Product Change Notification / SYST-27XBYV713

ERRATA - dsPIC33EPXXXGM3XX/6XX/7XX Errata Document Revision

dsPIC33EPXXXGM3XX/6XX/7XX Family Silicon Errata and Data Sheet Clarification

The dsPIC33EPXXXGM3XX/6XX/7XX family devices that you have received conform functionally to the current Device Data Sheet (DS70000689D), except for the anomalies described in this document.

FIGURE 1: TIMING DIAGRAMS FOR CENTER-ALIGNED AND EDGE-ALIGNED MODES

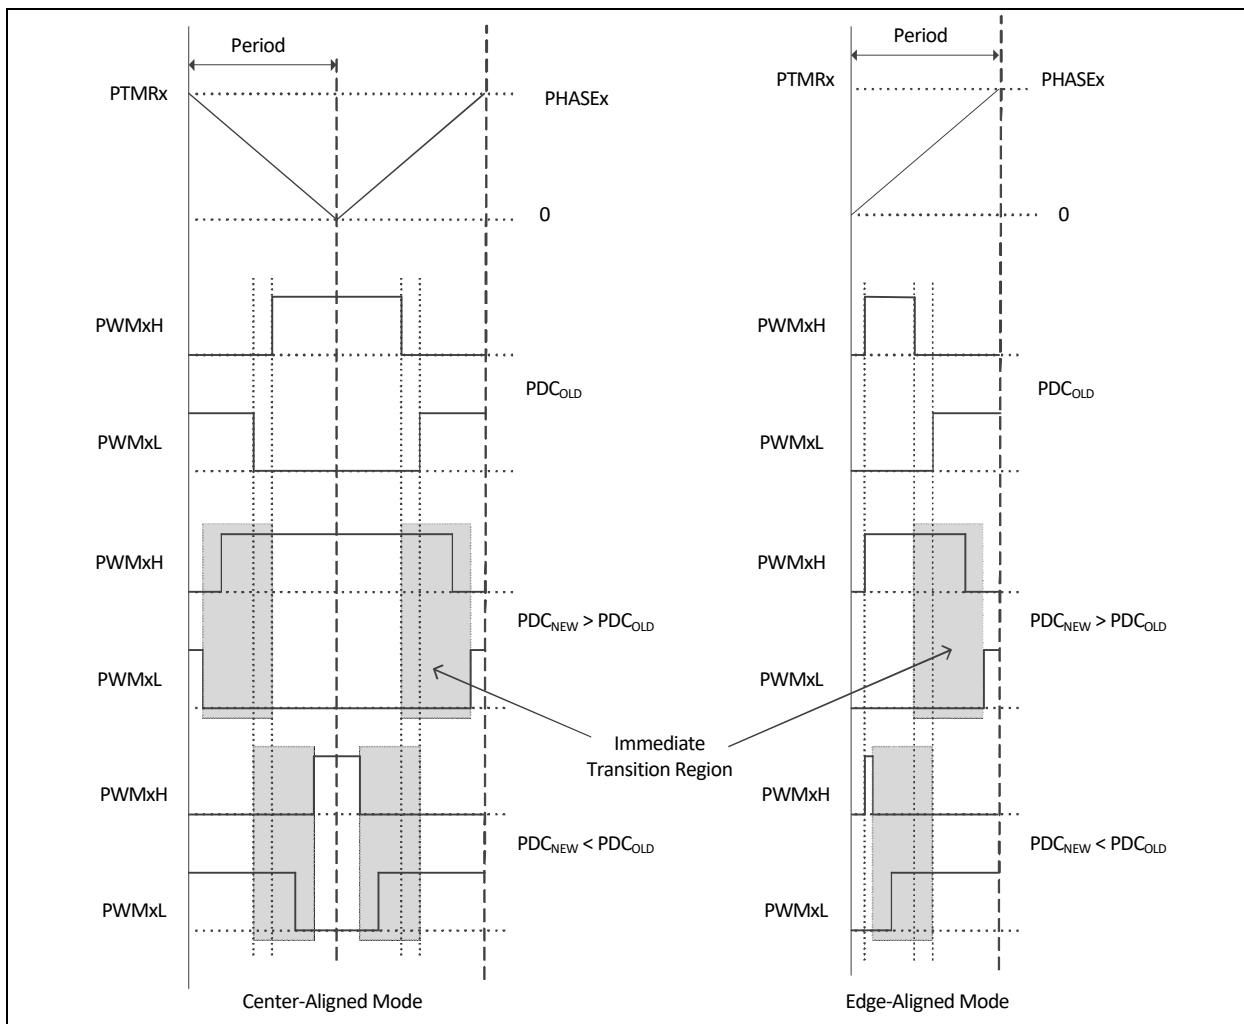
The PWM generator may not assert dead time on the edges of transitions. This has been observed when all of the following conditions are present:

- The PWM generator is configured to operate in Complementary mode with Independent Time Base (ITB) or master time base;
- Immediate update is enabled; and
- The value in the PDC register is updated in such a manner that the PWMxH and PWMxL outputs make an immediate transition.

In Figure 1, if the duty cycle write occurred in the shaded box, then PWMxH and PWMxL will make an immediate transition without dead time.

In most applications, the duty cycle update timing can be controlled using the TRIGx trigger, or Special Event Trigger, such that the above mentioned conditions are avoided altogether.

FIGURE 2: PWM GENERATOR TIMING DIAGRAM

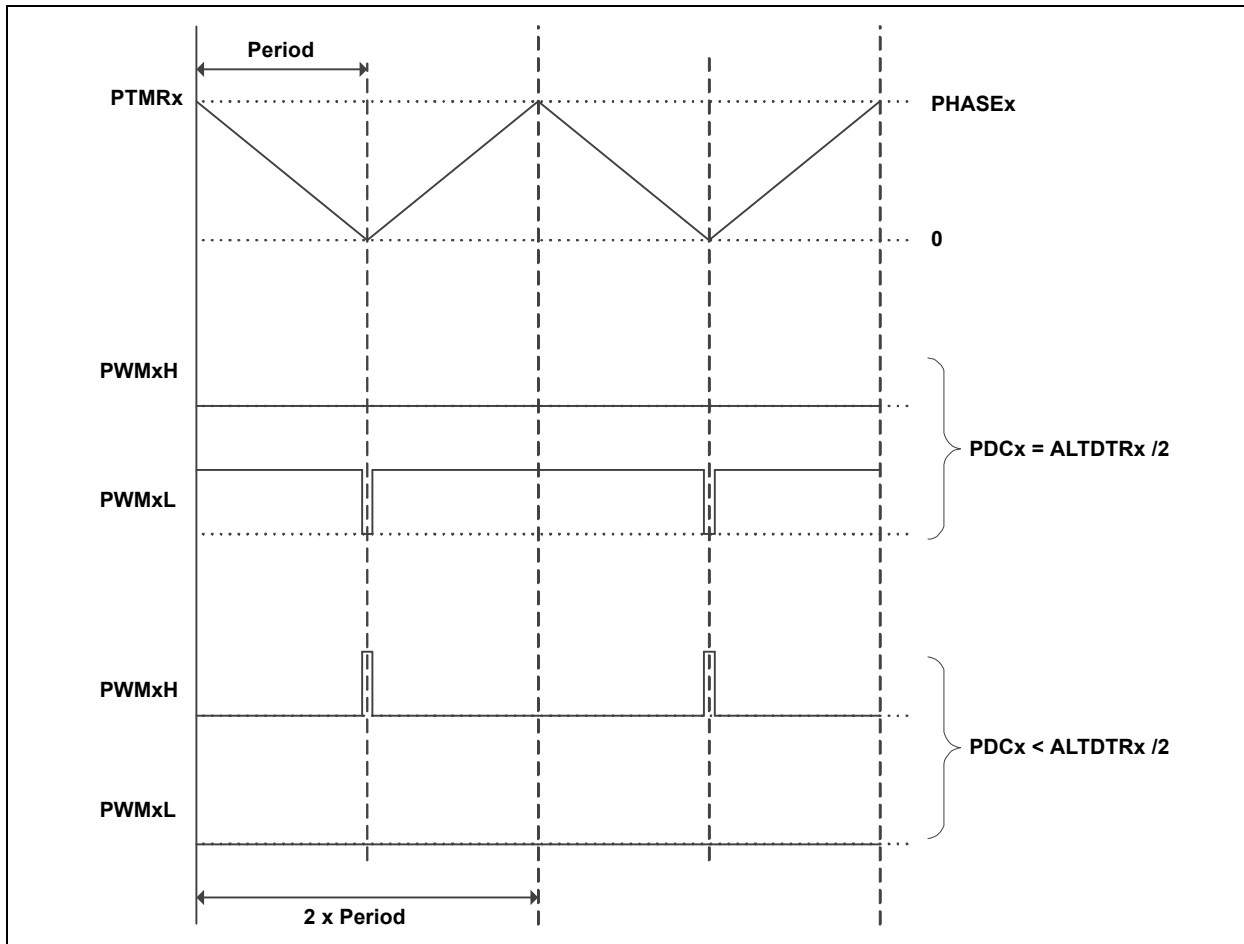
In Center-Aligned Complementary mode with Independent Time Base, if the value in the PDCx register is less than one-half the value in the ALTDTRx register, the PWM generator will force the PWMxL to low, and on the PWMxH, generates pulses of a width less than twice the dead time, as shown in Figure 2.

Include a software routine to ensure that the duty cycle value written to the PDCx register is at least one-half of the value in ALTDTRx. Example 1 shows one method, with PDCtemp representing the variable which has the value to be written to the PDCx register. Alternatively, for duty cycle values less than half the desired dead-time value, zero out the ALTDTRx register or dynamically reduce the value in the ALTDTRx register, such that ALTDTRx is always equal to $2 * PDCx$, as shown in Example 2.

FIGURE 3:

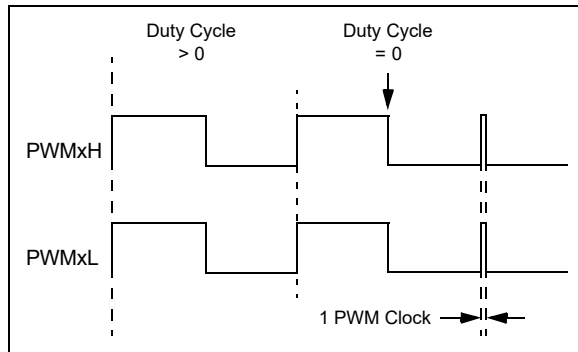
In certain output modes, the PWMx module produces a pulse glitch of one PWM clock in width (Figure 3). This has been observed only when all of the following are true:

- Either Redundant or Push-Pull Output mode is selected (IOCONx[11:10] = 10 or 01);
- Immediate Update is disabled (PWMCONx[0] = 0); and
- The value of the current Duty Cycle register (either the PDCx or MDC register, as determined by PWMCONx[8]) is updated to zero from any non-zero value.

The pulse glitch has been observed to occur at the beginning of the following PWM boundary period.

If the application requires a duty cycle of zero, two possible work arounds are available.

1. Use the PWM overrides to force the output to a low state, instead of writing a '0' to the Duty Cycle register. When using this method, the PWM override must be disabled when the duty cycle is a non-zero value. If output override synchronization is configured to occur on CPU clock boundaries (IOCONx[0] = 0), enabling and disabling the override must be timed to occur as closely as possible to the PWM period boundary.
2. Configure the module for Immediate Update (PWMCONx[0] = 1) *before* enabling the module. In this mode, writes to the Duty Cycle register have an immediate effect on the output. As with the previous work around, writes to the Duty Cycle register must be timed to occur as close to the PWM period boundary as possible in order to avoid distortion of the output.

FIGURE 4:

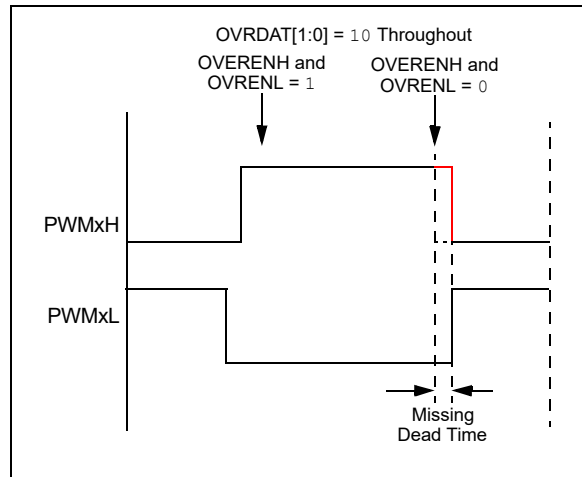
In Complementary Output mode, the expected dead time between transitions of the PWMxH and PWMxL outputs may not be asserted when the following occurs:

- Output override synchronization is configured to occur on the CPU clock boundary (IOCONx[0] = 0);
- Both PWMxH and PWMxL overrides are enabled prior to the event (OVRENH and OVRENL are both '1'), and
- Both overrides are disabled (OVRENH and OVRENL are both '0') at the instant the dead time should be asserted (Figure 4).

This has been observed in both Center-Aligned and Edge-Aligned modes.

FIGURE 5:

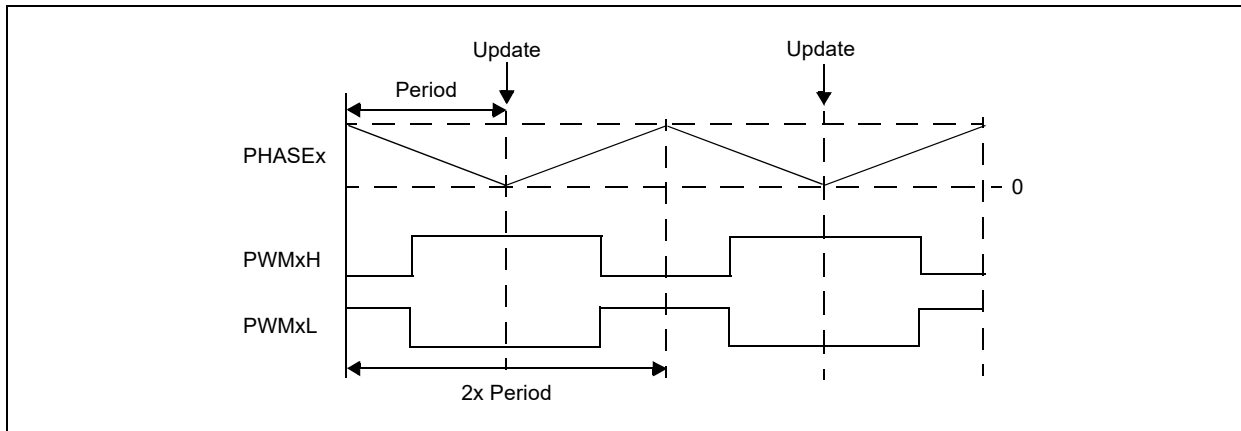
In Center-Aligned Complementary mode with Independent Time Base, updates to the PHASEx register take effect in the middle of a Center-Aligned PWM cycle, as shown in Figure 5. This occurs only when the Immediate Update feature is disabled (IUE = 0). If Immediate Update is enabled (IUE = 1), the PHASEx register updates will take effect immediately.

FIGURE 6:

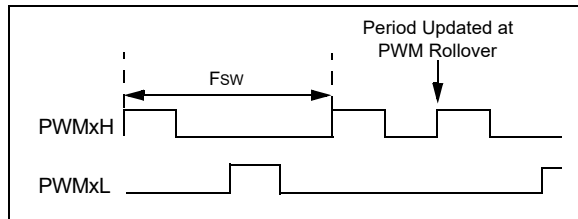
When the PWM module is configured for Push-Pull mode (IOCONx[11:10] = 10) with the Enable Immediate Period Update bit enabled (PTCON[10] = 1), a write to the Period register that coincides with the period rollover event may cause the push-pull output logic to produce back-to-back pulses on the PWMx pins (Figure 6).

Ensure that the update to the PWM Period register occurs away from the PWM rollover event by setting the EIPU bit (PTCON[10] = 1). Use either the PWM Special Event Trigger (SEVTCMP) or the PWM Primary Trigger (TRIGx) to generate a PWM Interrupt Service Routine (ISR) near the start of the PWM cycle. This ISR will ensure that period writes do not occur near the PWM period rollover event.

FIGURE 7: SIMPLIFIED BEHAVIOR

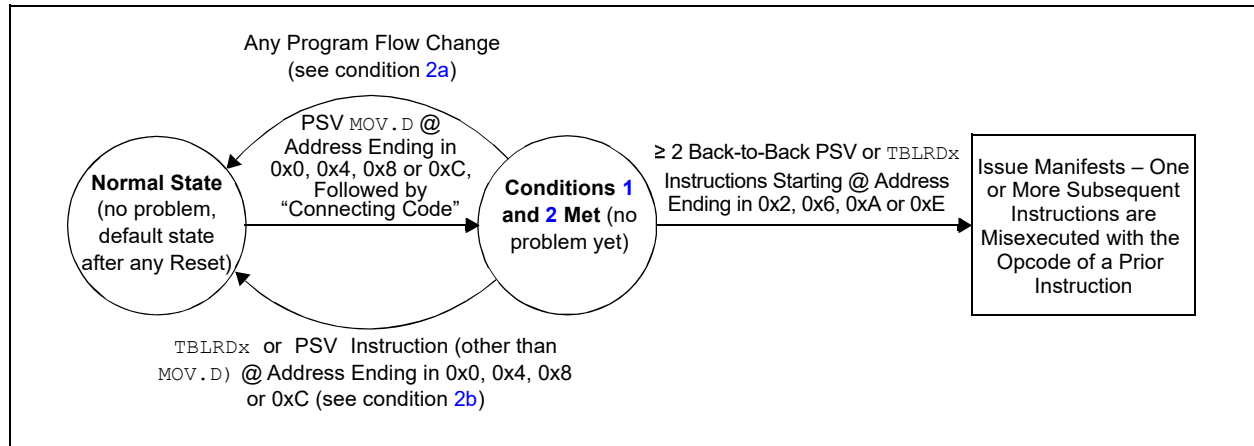
3.	≥ 2 back-to-back PSV or <code>TBLRDx</code> instructions are executed (following the code of condition 2), where the first of the back-to-back instructions is located at an address ending in 0x2, 0x6, 0xA or 0xE.

[Figure 7](#) provides an example of the effective behavior.

1. All instances of PSV MOV.D can be replaced with two PSV MOV instructions instead. Non-PSV MOV.D instructions acting on RAM/SFRs do not need to be modified; or
2. If not already present, a program flow change instruction (such as BRA \$+2) can be inserted above back-to-back data Flash read sequences; or
3. Back-to-back data Flash read instruction sequences can be broken up by inserting a non-Flash read instruction (such as a NOP), in between the Flash read instructions; or
4. The alignment of the code can be shifted to avoid the required opcode location addresses.

C code built with MPLAB® XC16 Compiler Version 1.32, or later, implements the work around by default. However, if the application uses Assembly language routines, these should be manually modified to implement the work around. Additionally, if precompiled libraries are used, these should be built with XC16 Version 1.32 or later. For additional information, please visit: www.microchip.com/erratum_psrds_psrds

64-Lead Plastic Quad Flat, No Lead Package (MR) – 9x9x0.9 mm Body with 5.40 x 5.40 Exposed Pad [QFN]

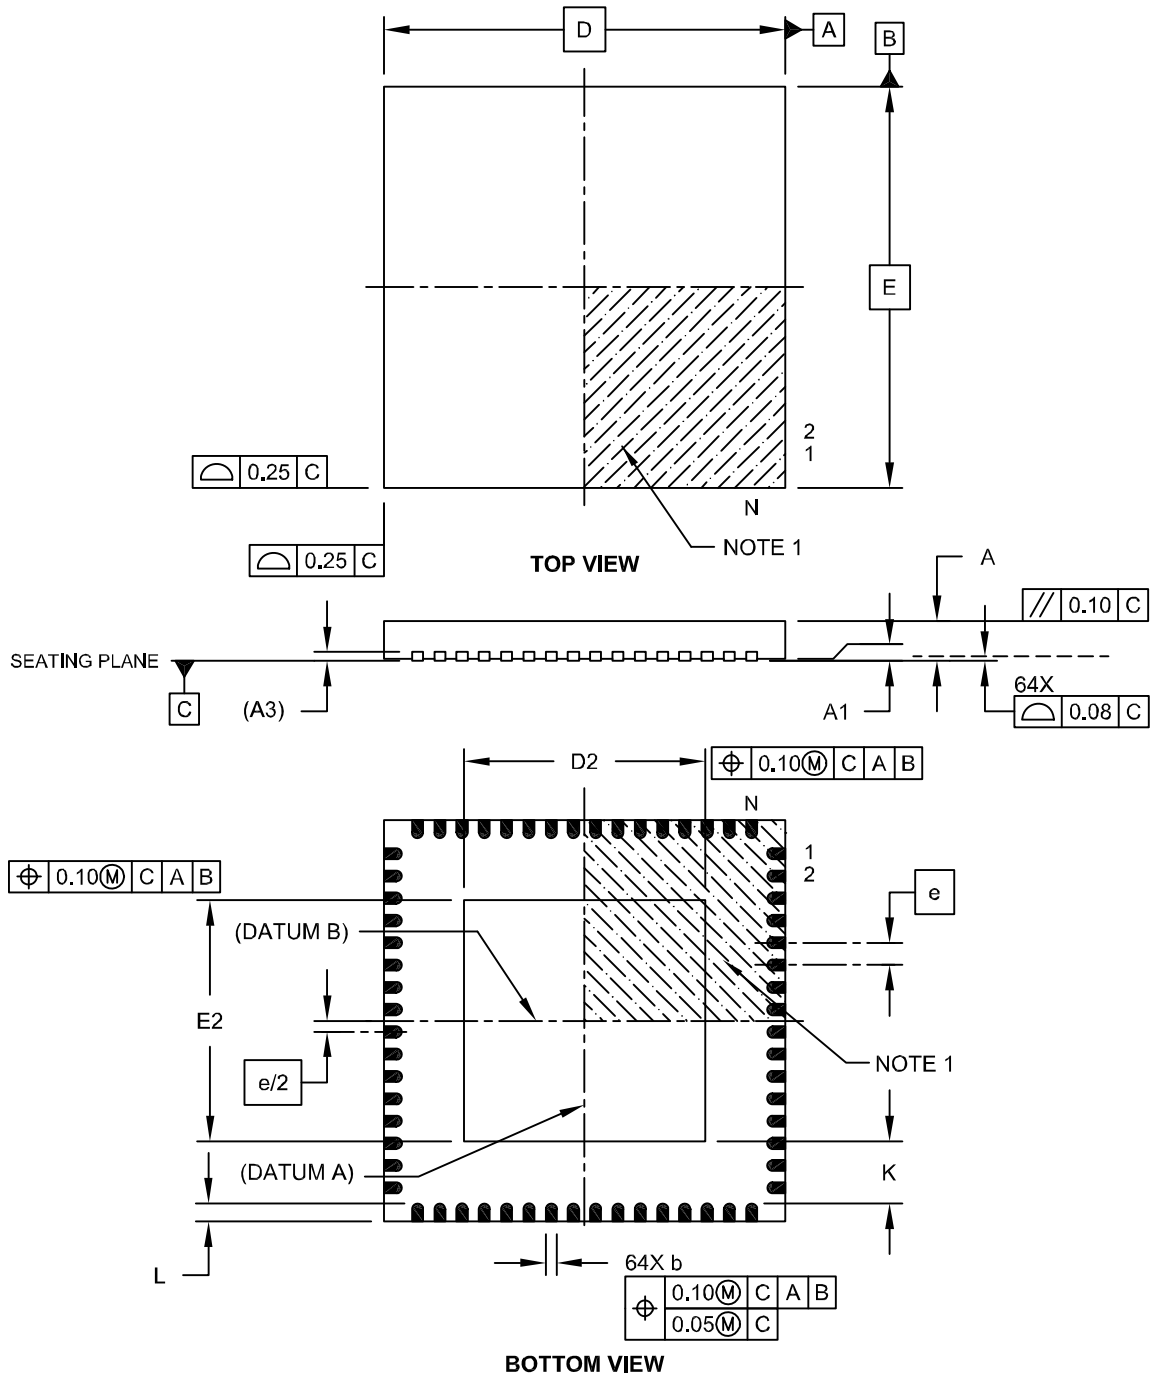
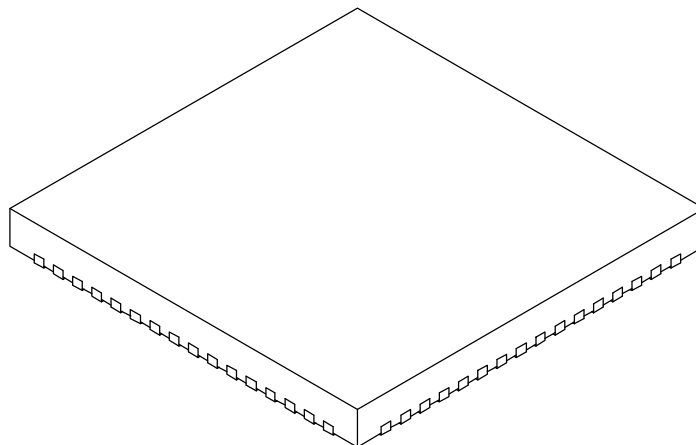
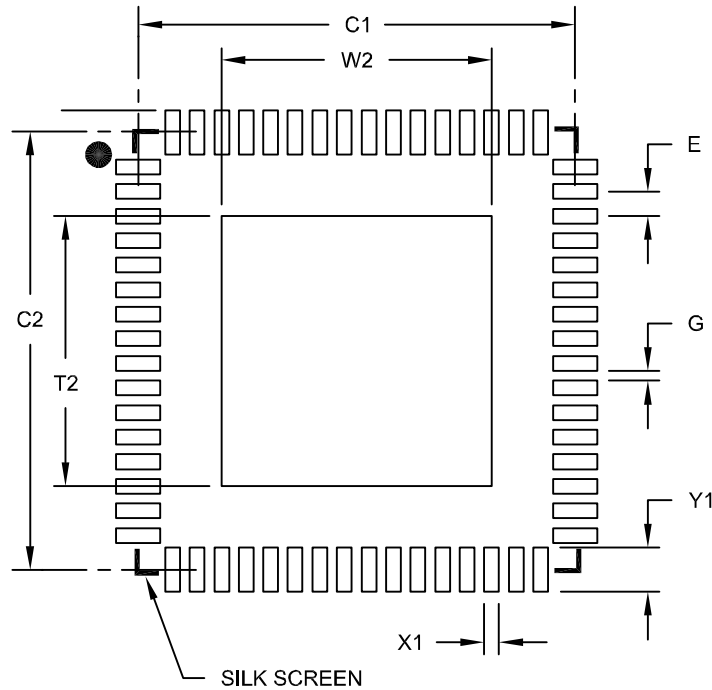
In the “*dsPIC33EPXXXGM3XX/6XX/7XX Family Data Sheet*”, **Section 35.2 “Package Details”**, dimensions for the 64-Lead Plastic Quad Flat, No Lead Package (MR) – 9x9x0.9 mm Body with 7.15 x 7.15 Exposed Pad [QFN] is mentioned. However, the dsPIC33EPXXXGM3XX/6XX/7XX family devices are not available in this package.

The dsPIC33EPXXXGM3XX/6XX/7XX family devices are available in the 64-Lead Plastic Quad Flat, No Lead Package (MR) – 9x9x0.9 mm Body with 5.40 x 5.40 Exposed Pad [QFN], and the package dimensions are shown on the following pages.
